NORTHERN BEACHES LOCAL PLANNING PANEL MEETING

WEDNESDAY 21 OCTOBER 2026

4.1 Mod2026/0228 - 1749 Pittwater Road MONA VALE - Modification of Development Consent DA2025/0143 granted for demolition works and construction of a shop top housing development including basement car parking 6

APPLICATION FOR MODIFICATION ASSESSMENT REPORT

Figure 12 - Comparison of the Approved (left) and Proposed (right) L2 COS

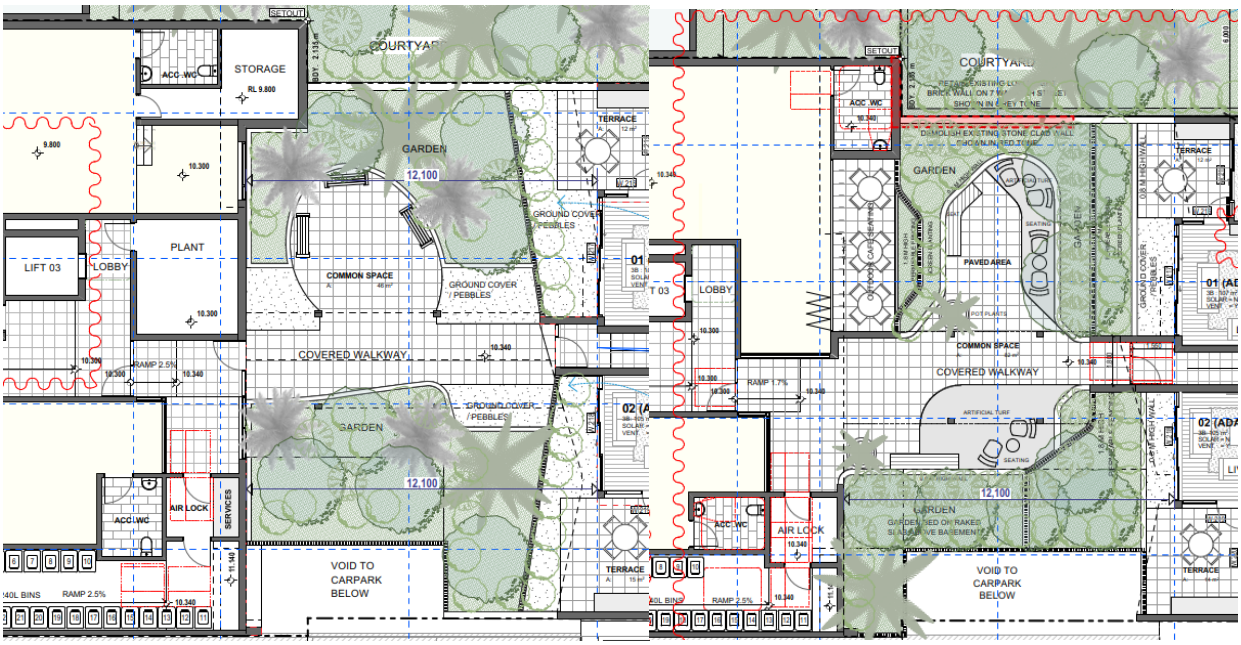
The proposed modifications seek a modified and reduced communal open space (COS). As amended, the provision is $296m^2$ (19.4% of the site area).

The main area of reduction occurred in the western Level 2 communal open space. A comparison of the two designs is provided below.

The primary amendment affecting the size of the space is the redesign and extension of Retail 03 to (in part) create a modest courtyard seating area.

Figure 15 – Approved Pittwater Road frontage

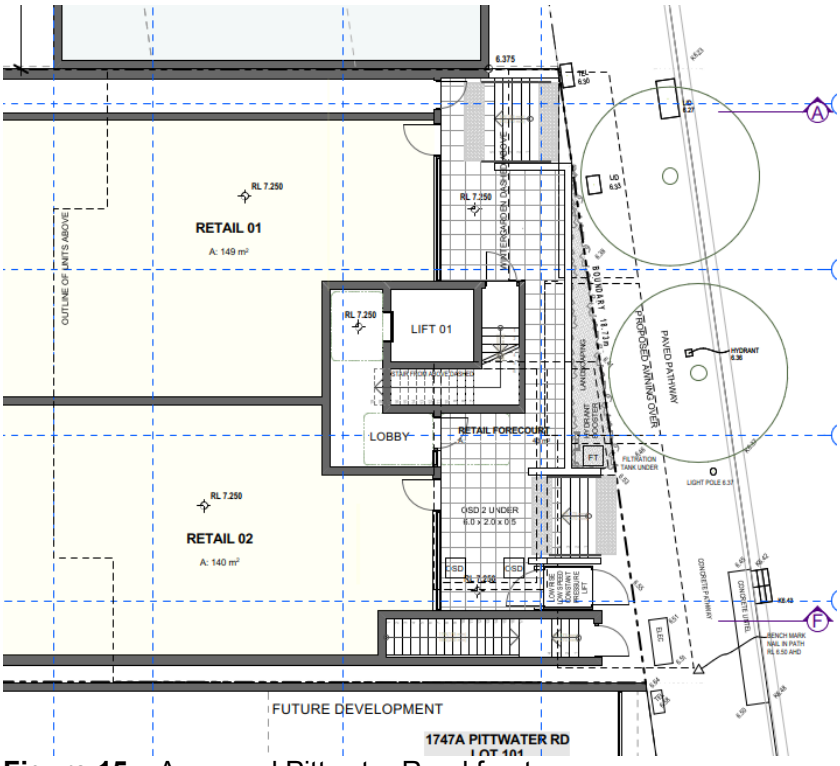
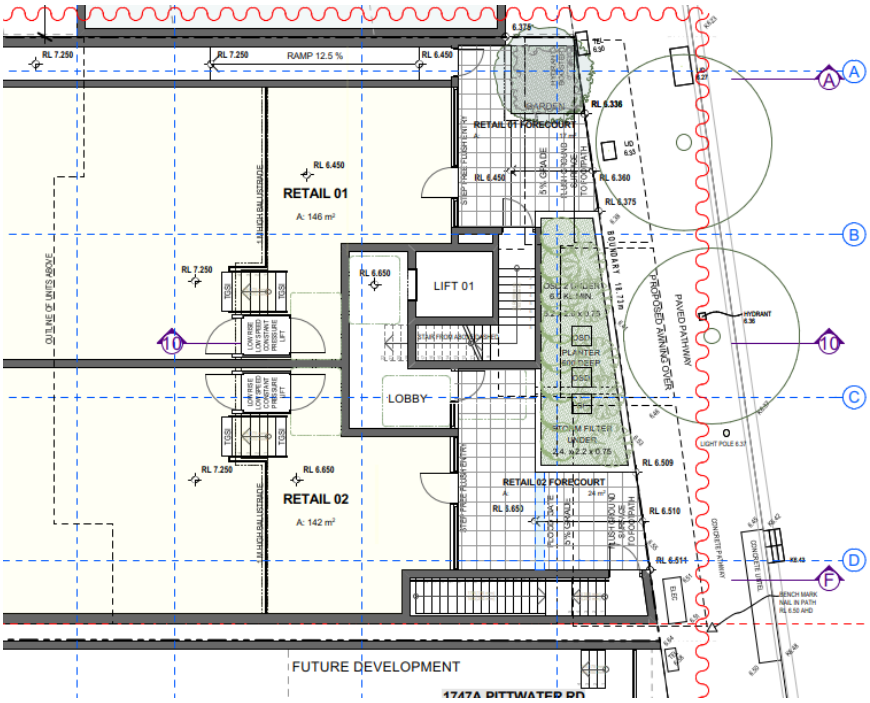
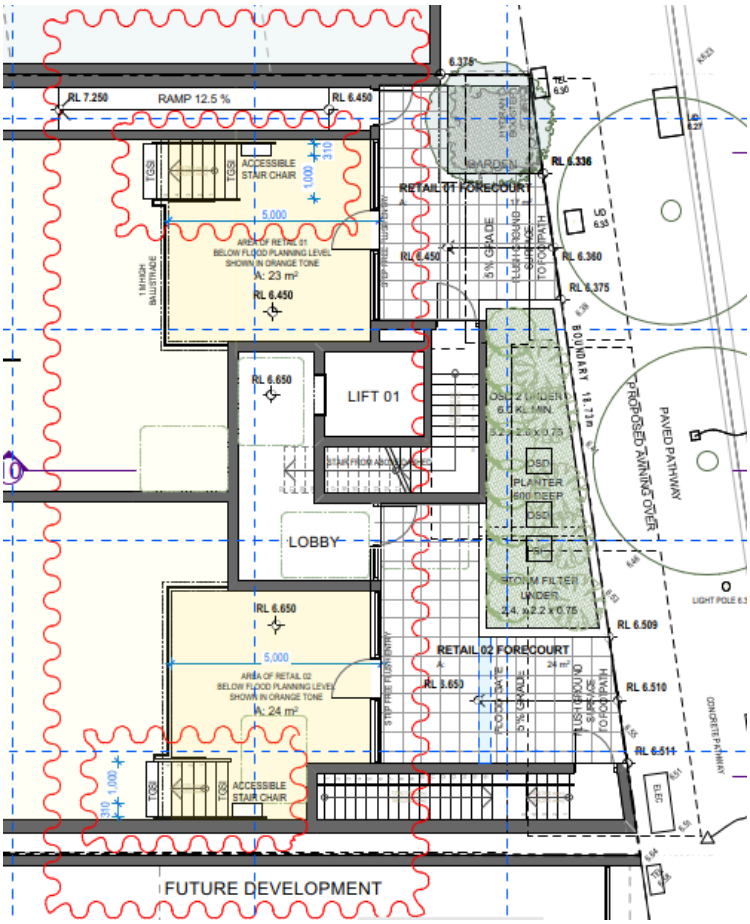
The proposed modification sought to lower Retail 01 and 02 and the front setback (including residential lobby) closer to street level. Refer to the lodged Pittwater Road frontage design below.

The proposed design will result in the front setback, front portion of Retail 01 and Retail 02, and the residential lobby sitting below the FPL. To address the flood risk, a flood gate was proposed, indicated by the blue line in **Figure 16**.

Council's Flood Engineer was initially not supportive of the amendment. Further information was requested to support the flood gate approach and was submitted in the form of additional flooding advice and acknowledgement of existing flood gates in Mona Vale and in Northern Beaches more broadly. A modest update to the design of this area was also part of the additional information, shown below.

Council's Flooding Engineer supported the additional information subject to conditions of consent ensuring flood compatible materials are used for construction of the elements below the FPL, and all electricity equipment, power points and wiring are above the FPL. These conditions are included in the amended conditions in this report.

Figure 18 – Approved (left) and Proposed (right) Level 3 front setbacks

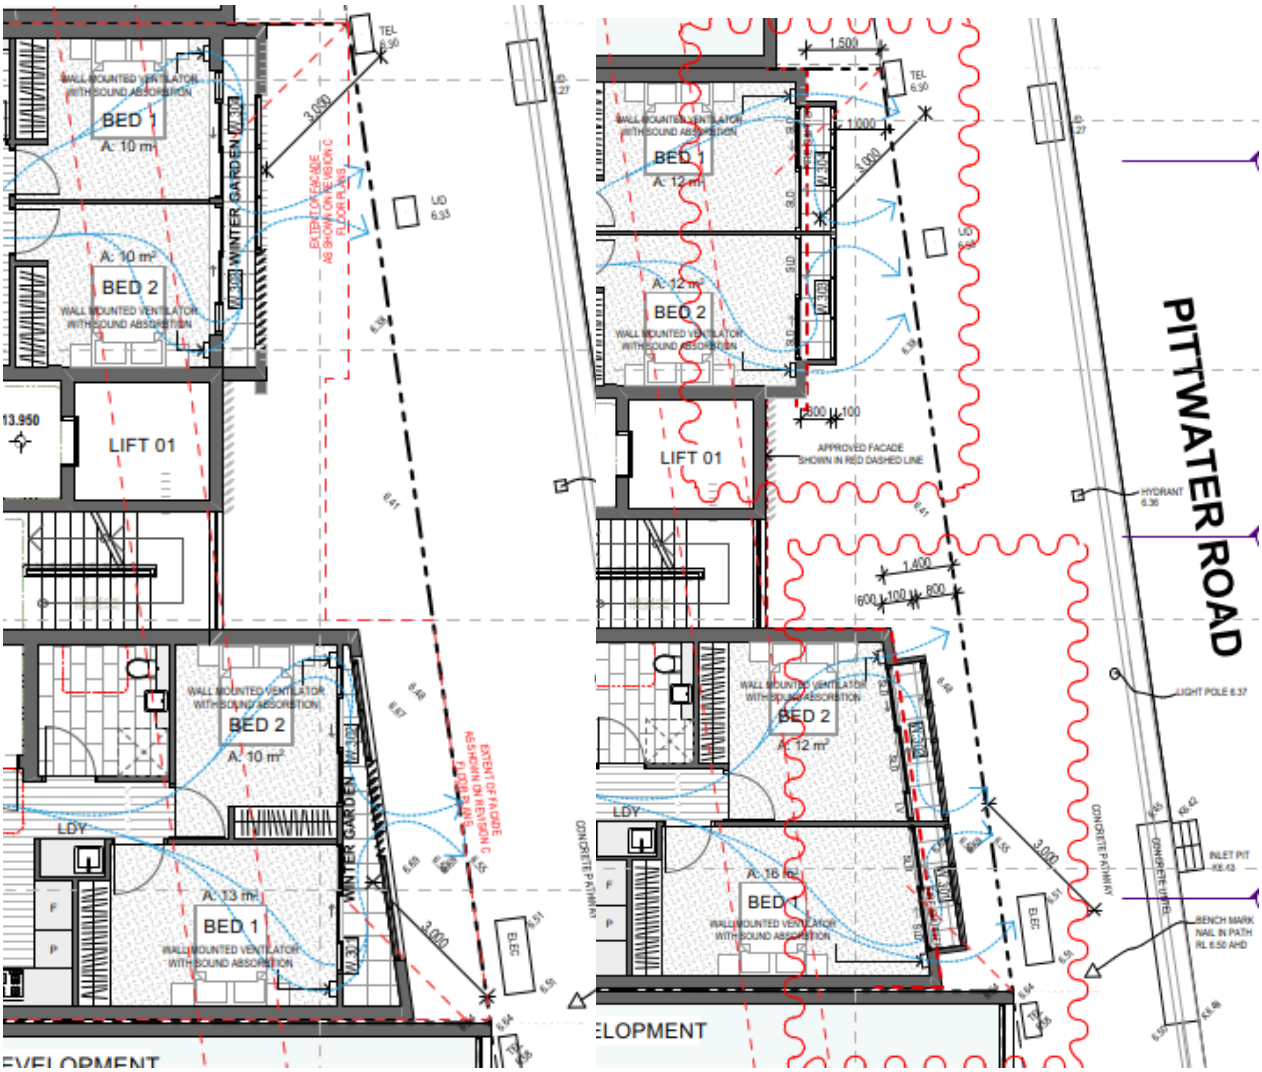
It is proposed to reduce the front setback to Pittwater Road on Levels 2, 3 and 4. A comparison of the approved and proposed Level 3 plan is shown in **Figure 18** below.

The key amendment is the enclosure of the approved wintergardens to extend the bedrooms and the addition of new, narrower, 600mm deep wintergardens which further encroach into the front setback. This occurs on Levels 2 and 4 in the same fashion as illustrated in **Figure 18** above.

NORTH EAST ELEVATION

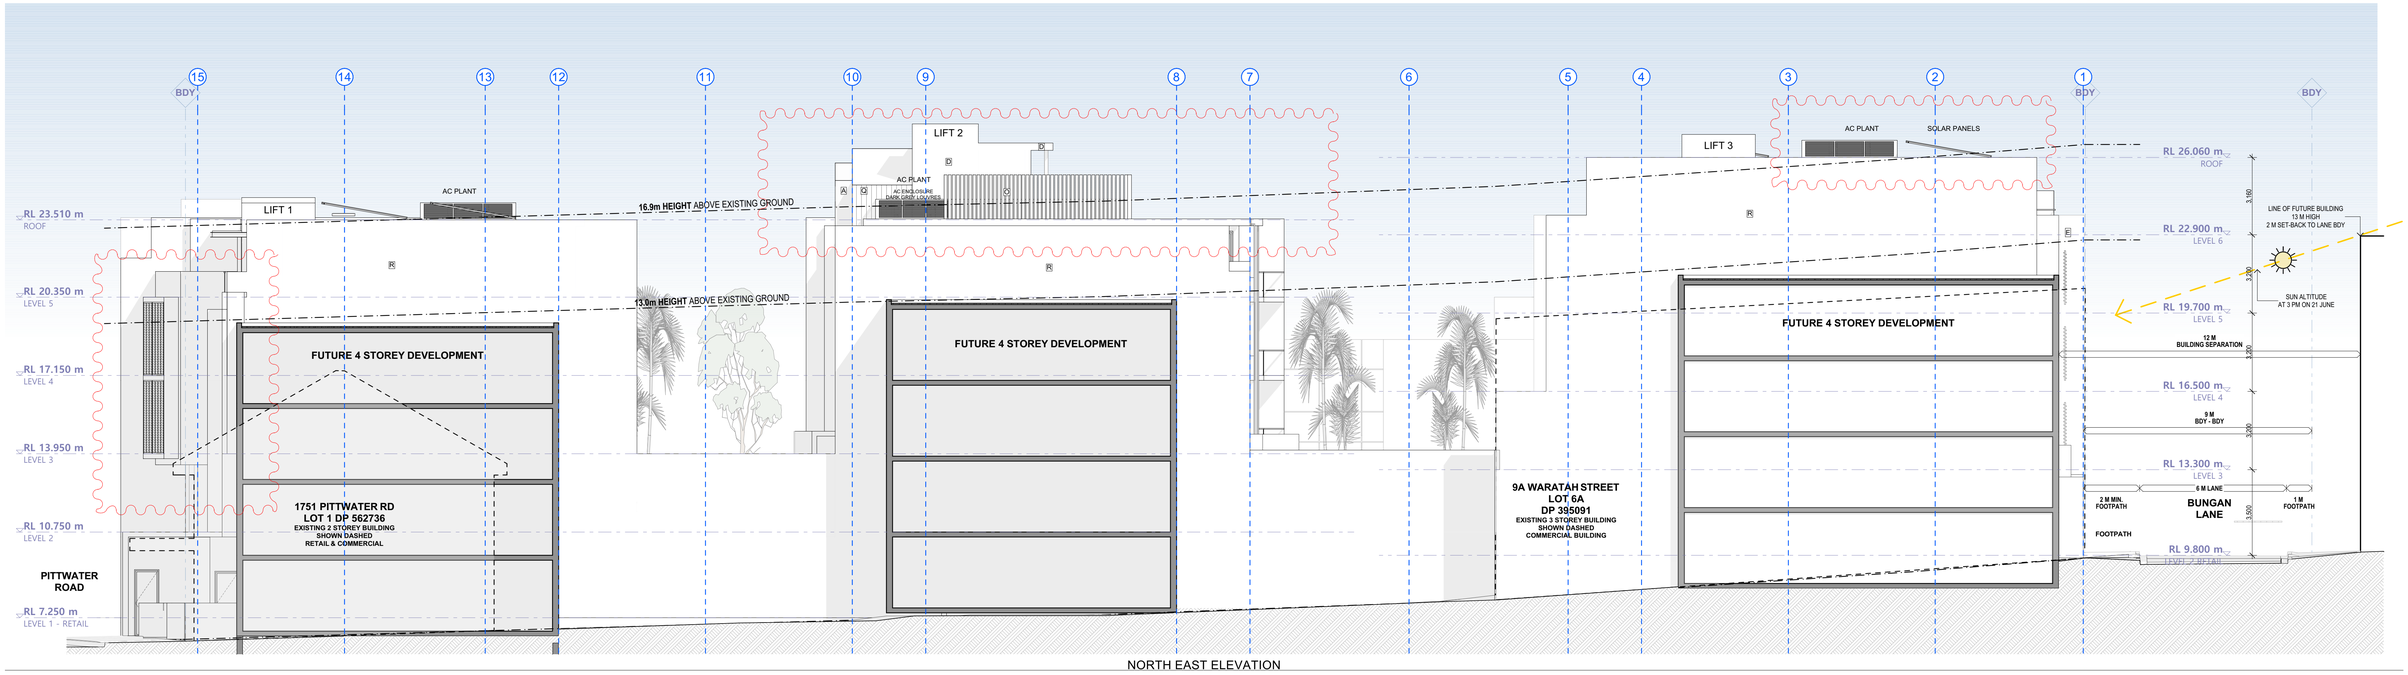
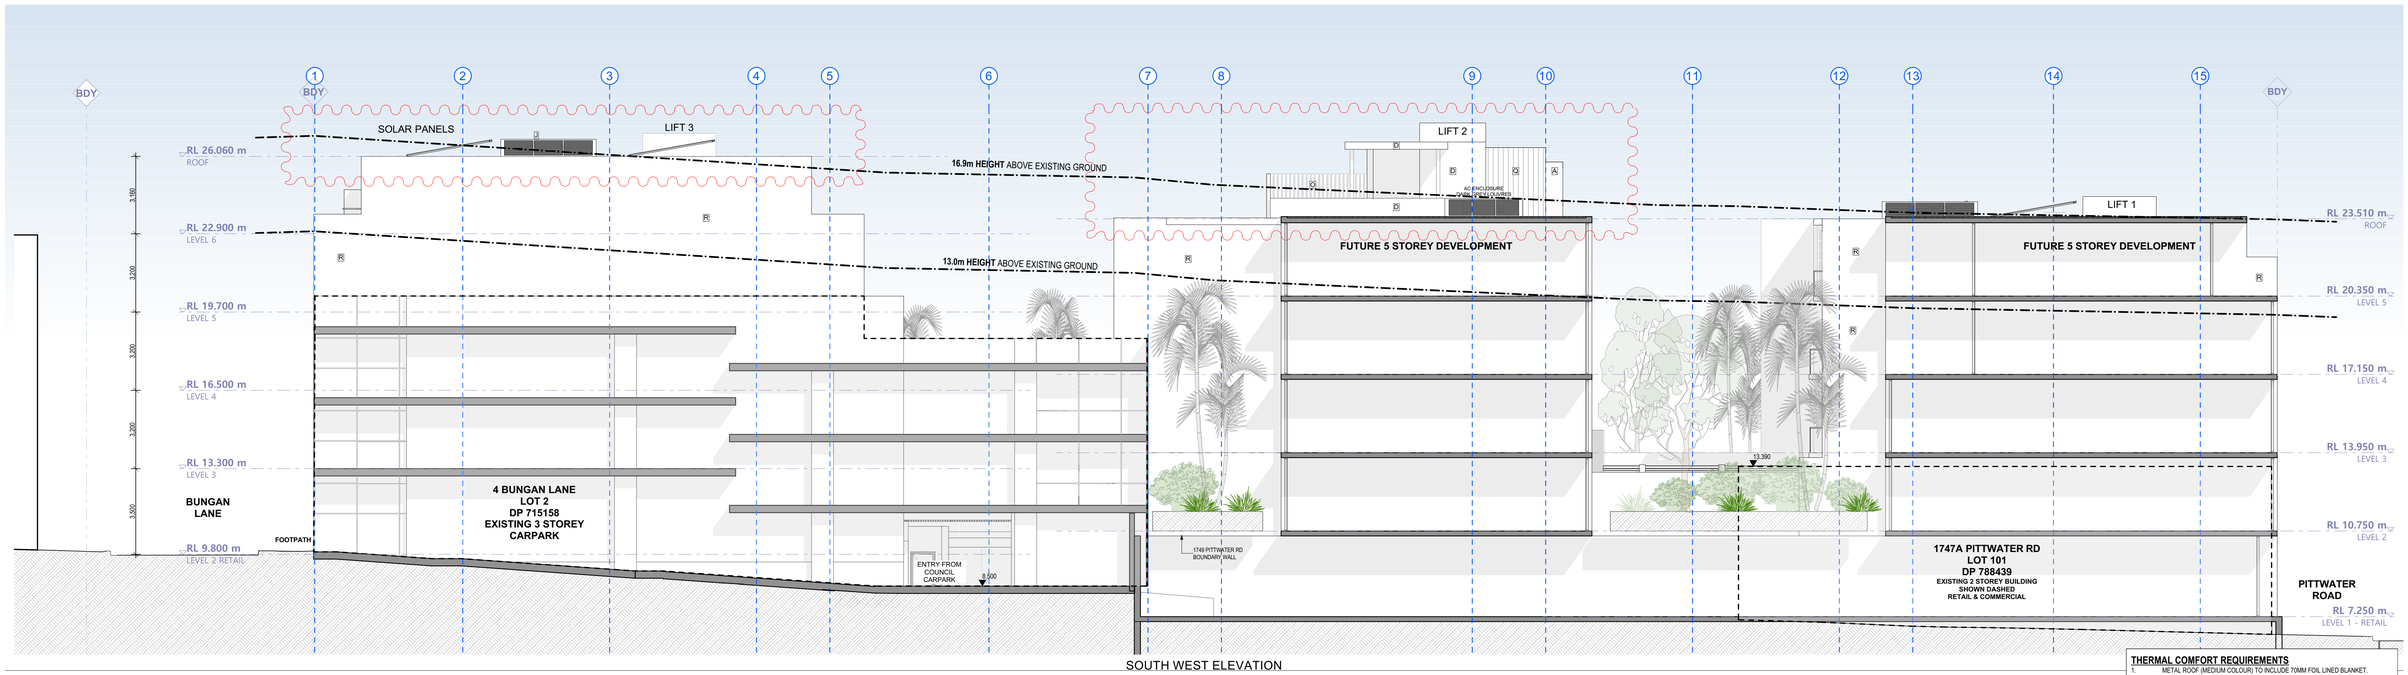
REV J:
- WINTERGARDENS REINSTATED.
- ROOFTOP COS REINSTATED.
- SOLAR PANELS ADDED.
